# Fire Risk Assessment

Property assessed: B Hodgson Court Nightingale  
Avenue London HA1 3GX

Client: Network Homes Ltd

FRA Inspection Date: 01/09/2020  
FRA Issued to Client: 21/10/2020  
FRA valid to: 21/10/2021  
FRA completed by: Savills (UK) Ltd,  
33 Margaret Street, London W1G 0JD  
T: 020 7409 8737  
E: fireriskhousing@savills.com

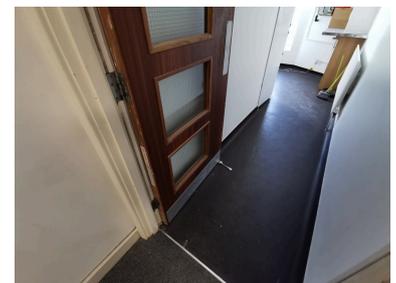
Comment: Missing or damaged smoke seals were noted to the following Doors-The double doors to service/store cupboards do not have intumescent strips and cold smoke seals to the meeting stiles of the doors, smoke seals missing from the top of the heating cupboard door frame (BO3), 1st-floor cross-cluster/block door, 1st floor cluster kitchen door 162, 1st floor service cupboard door B12, top floor cross cluster/block door, top floor cluster kitchen door 263. In addition to the above - missing combined intumescent strips and cold smoke seals were also noted to the link door to block A and block C.

Recommendation: Common area fire doors as noted should be fitted with intumescent strips and smoke seals.

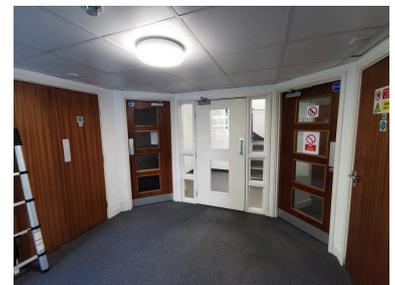
Comment: Fire door signage is not considered adequate. Fire door signage is required for the following doors: B03, B04, B11, B12, B13, B21, B22, and B23 require 'Fire door keep locked' signage - these doors are either provided with the wrong fire door signage or a double door set (each openable fire door should be fitted with fire door signage) The ground floor stairwell door requires a 'Fire door keep closed' sign to both sides of the door at eye level.

Recommendation: Provide 'Fire door keep locked' notices to common area fire doors as noted.

Recommendation: Provide 'Fire door keep shut' notices to common area fire doors as noted.
